MEMORANDUM

Project Name: GOVERNOR'S LAND - PHASE I
Structure/BMP Name: DRY DETENTION POND #2
Project Location: ROUTE 5
BMP Location: END OF PRIVATE DRIVE AT END OF WEST ISLAND ROAD
County Plan No.: S - 7 - 90

DRAINAGE AND EROSION CONTROL PLAN
GOVERNOR'S LAND
OWNER DEVELOPER: GOVERNOR'S LAND PARTNERS
JAMES CITY COUNTY, VIRGINIA

Re: Governor's Land - Halfway House BMP
County Plan No. S-7-90
Stormwater Management Facility
County BMP ID Code: JR 025

Designed AES	Drawn AES
Scale 1" = 100'	Date JAN, 1999
Project No. 7173	
Drawing No. 31	Count

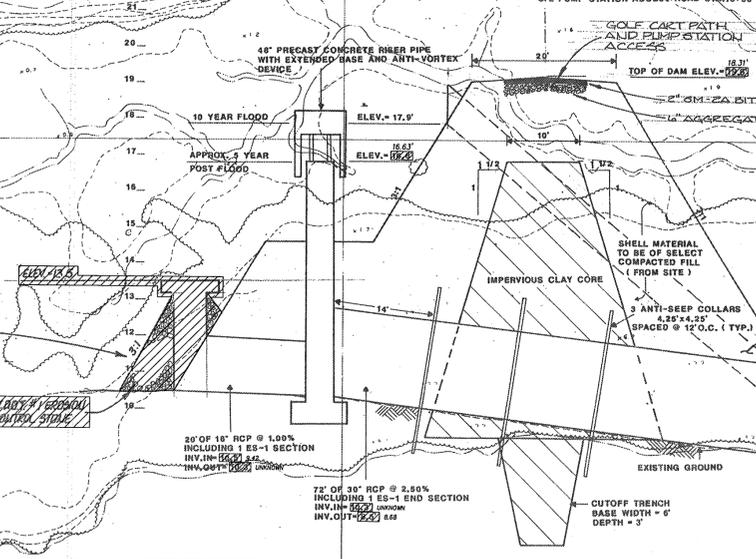
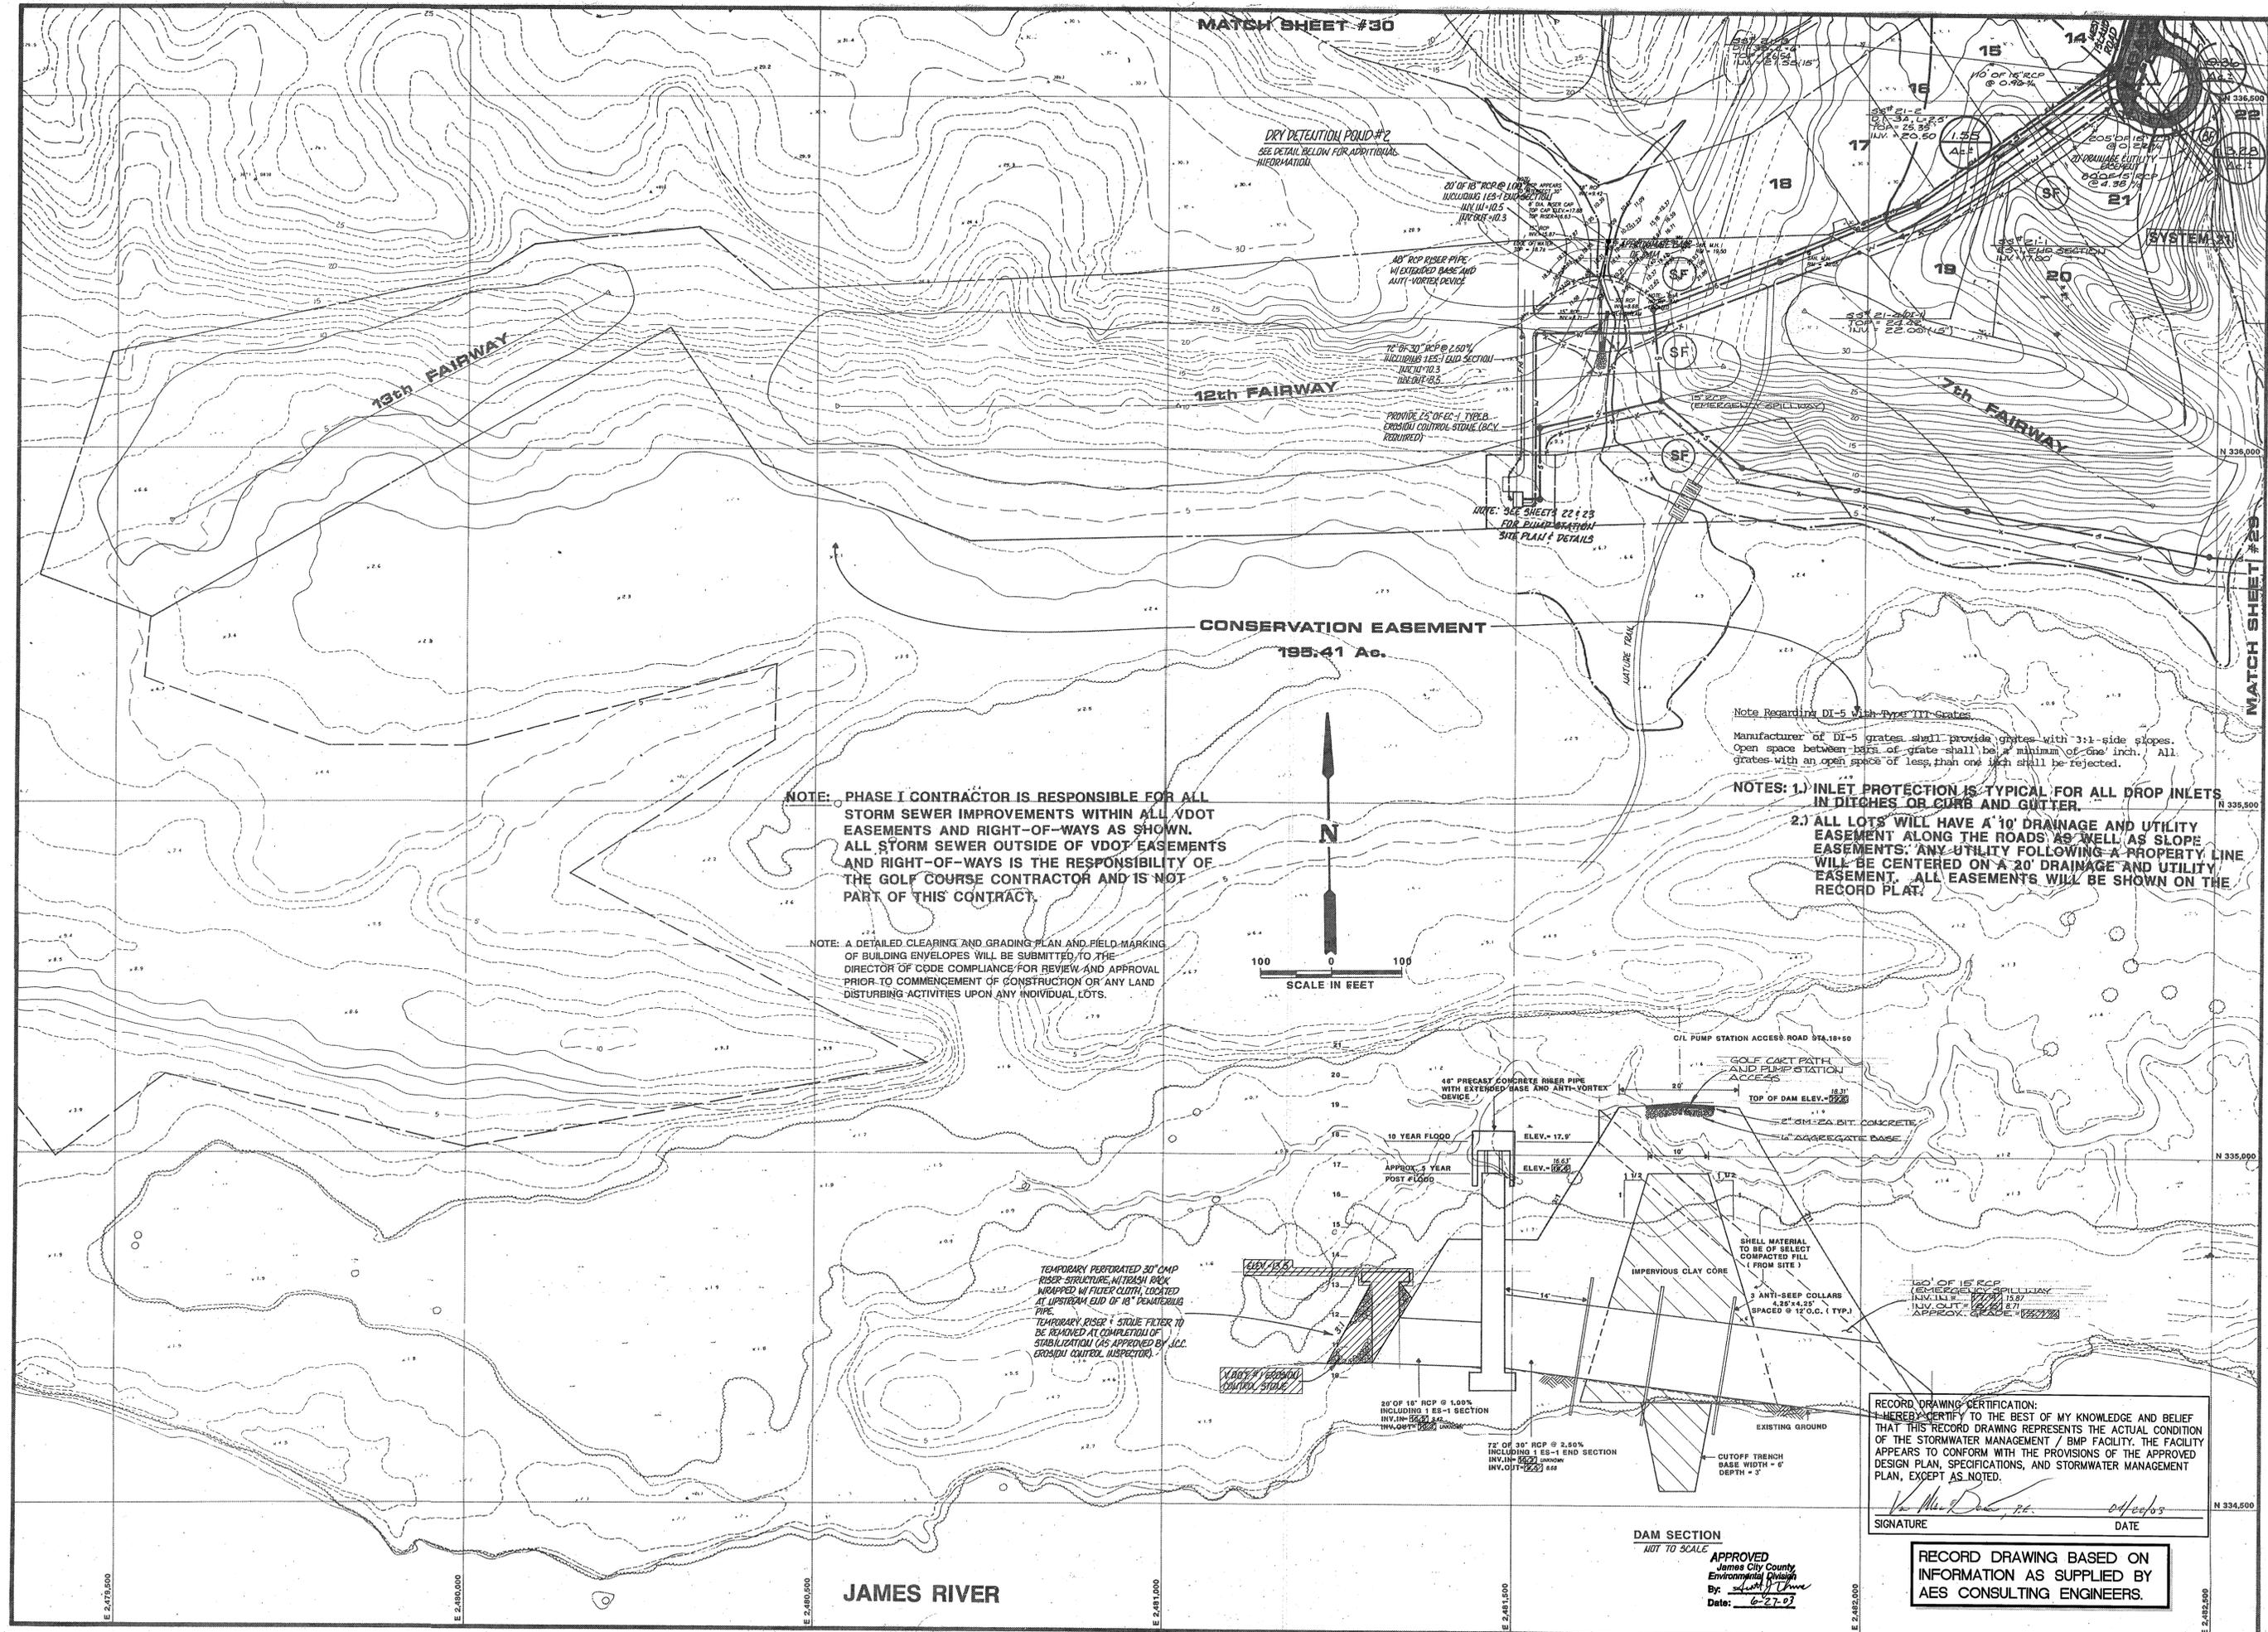
- ✓
6-22-03 2. The record drawing set dated June 8th 2001 is **satisfactory**. Please forward one reproducible and one blue/black line set of the record drawings to our office.

- ✓
3-11-03 3. Remove small trees and woody vegetation from the dam embankment, especially the downstream face of the dam.
- 4. Clean and remove all fallen tree and dead log debris from the interior of the basin area.

Reestablish outlet protection rock per the approved plan specifications.

Small trees and woody vegetation have been removed from dam area. All fallen trees and dead log debris have been removed from interior of basin area. 18-inch RCP has been repaired and reconnected to the riser and the area has been back filled then seeded and mulched after completed work. 30-inch RCP outflow pipe was inspected and some minor repairs were needed to stop undermining of flared end. Outflow protection was reestablished per approved plans.
